ADDENDUM 01

PROJECT: Cherokee Nation of Oklahoma

Jack Brown Center - Phase II

PROJECT #: 24-08.59

WALL SECTIONS **DETAILS**

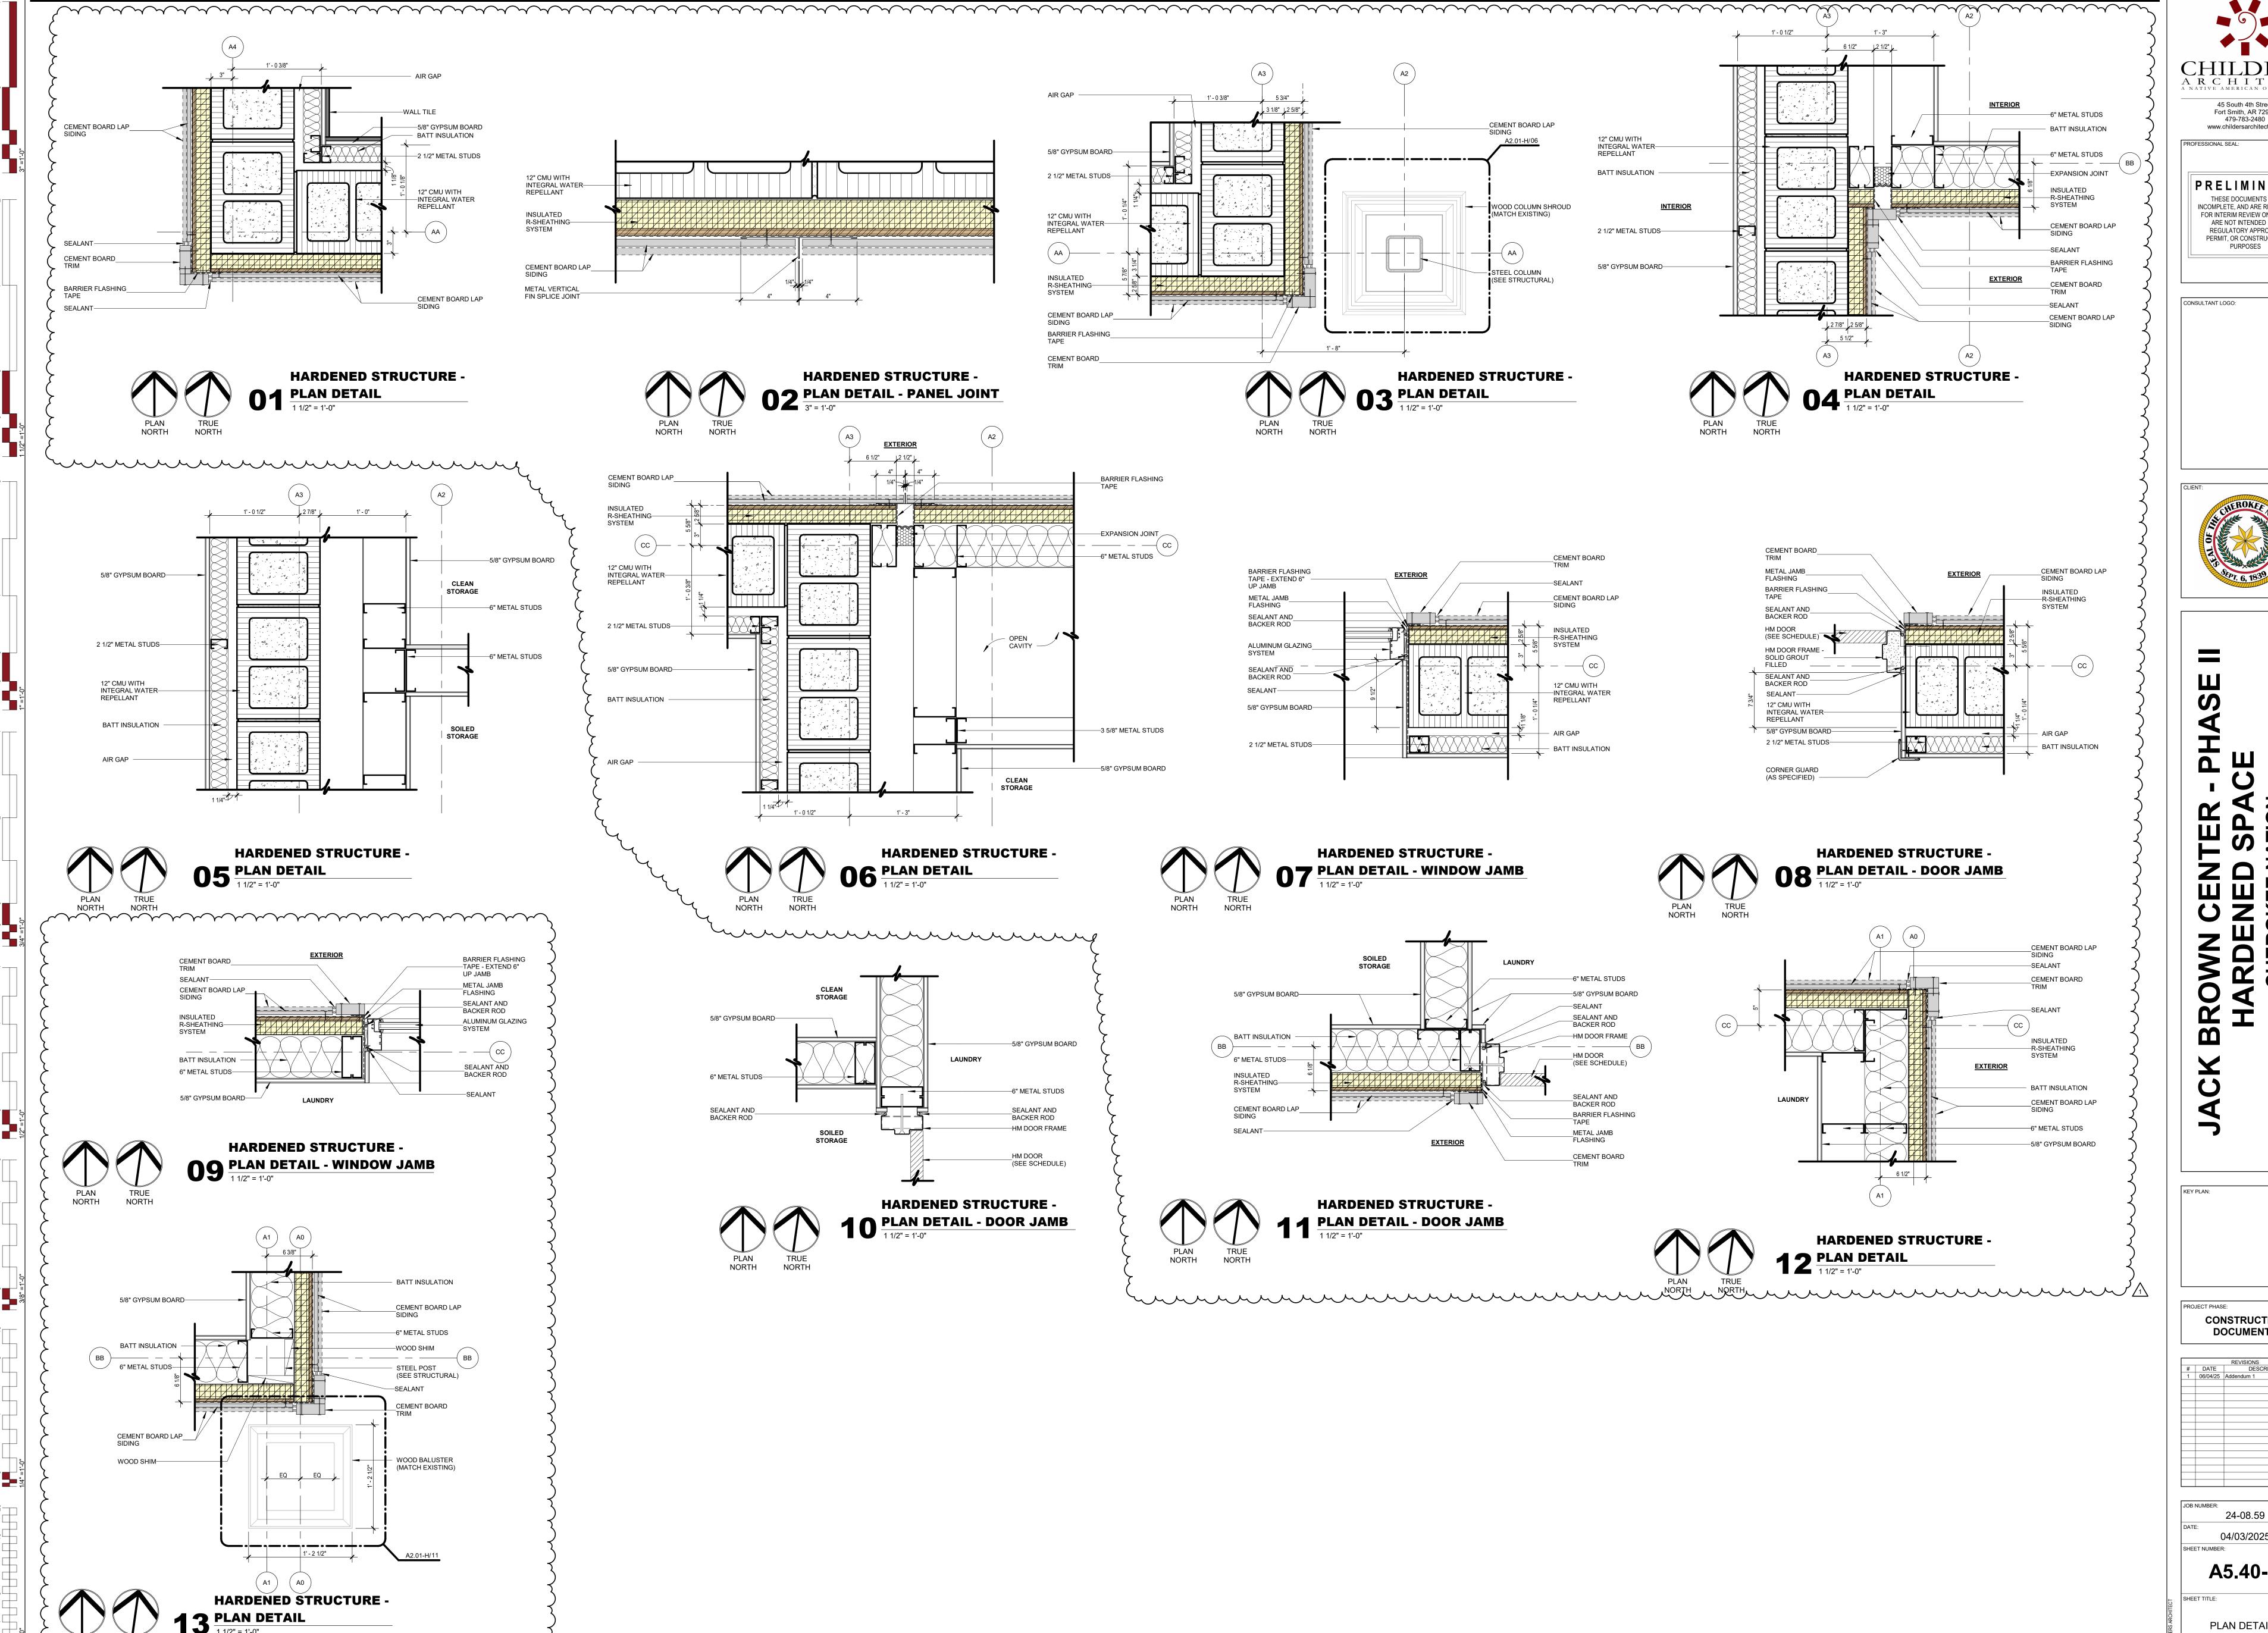
3. Substitute Fiber Cement plank siding in lieu of metal siding. Affected sheets/details: (Revised sheets found at the end of Addendum 01):

- a. Sheet A5.01-H, details 01, 03, 04, 06, 09
- b. Sheet A5.02-H, details 01, 02, 03, 04, 05, 06, 07, 08, 09
- c. Sheet A5.40-H, details 01, 02, 03, 04, 06, 07, 08, 09, 11, 12, 13
